BULLETIN 481 TIMBER WINDOWS

Amendment to cover photo to Bulletin 481:

Timber Window Elevation

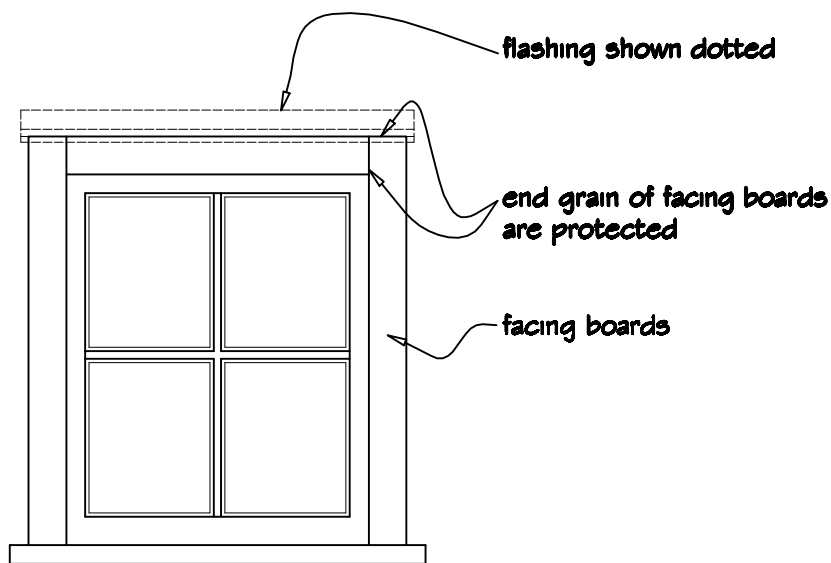
BRANZ does not recommend that facing boards are installed in the way shown in this photo.

The two vertical facing boards should be continuous to the underside of the head flashing, with the horizontal facing board fitted between them. In this way, the exposed end grain of the facing boards are protected.
